**UNITED  
TECHNOLOGIES  
CARRIER**

BULLETIN: CA-SB-19-E-76-81  
DATE: 9/27/76  
PAGE: 1 OF: 2

## SERVICE BULLETIN

**OIL DIFFERENTIAL PRESSURE GAUGE DESIGN CHANGE**

FIG. 1

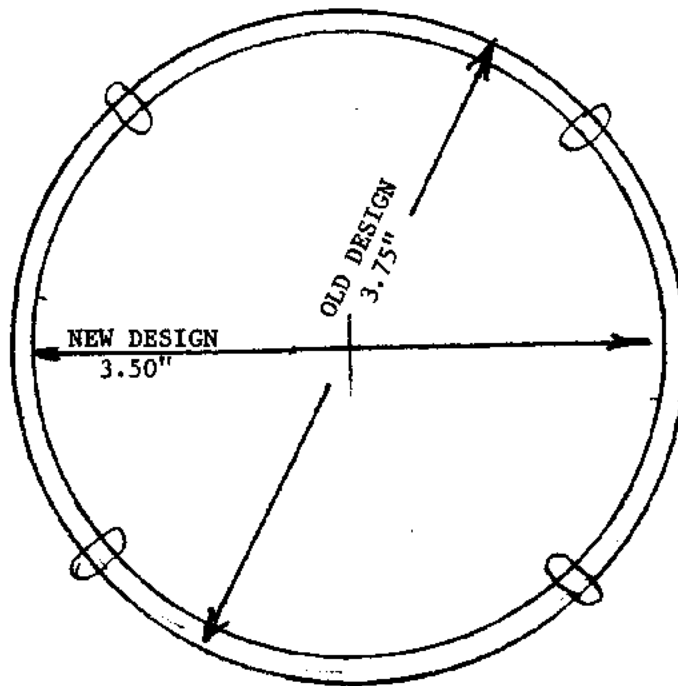
To advise of a change to the bolt circle diameter of the oil differential pressure gage.

Figure 1 shows the dimensional differences between the old and new design. A machine shipped before July 9, and with a serial number lower than 25,028, is most likely to have the old design gage. Service Parts no longer stocks the old design. If replacement is necessary, use the following installation method:

COMPARISON OF BOLT CIRCLES  
OLD DESIGN TO NEW DESIGN  
PN KM05BW220

1. Remove the old gage and its connecting piping.
2. Remove the four screws that hold the plastic cover onto the new gage.
3. The existing holes in the panel will have to be elongated to match the bolt pattern of the new gage. Use the plastic cover in Step 2 as a guide. We suggest using a rattail file, but make sure that the filings are collected and not allowed to fall into the panel.
4. Install the new gage and its connecting piping (see Fig. 2).

ELONGATED HOLES  
SHOULD APPEAR AS  
SHOWN

FIG. 2

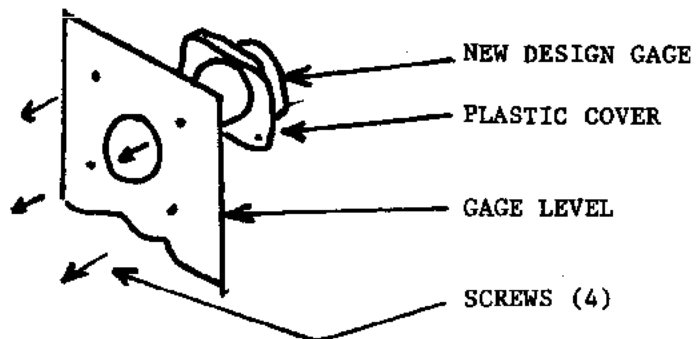
USING PLASTIC COVER OF NEW DESIGN GAGE AS A TEMPLATE,  
ELONGATE HOLES IN CONTROL PANEL TO MATCH BOLT CIRCLE.

AFTER USE AS TEMPLATE, REPLACE  
PLASTIC COVER AND INSTALL  
COMPLETE ASSEMBLY FROM REAR  
OF PANEL AS SHOWN.
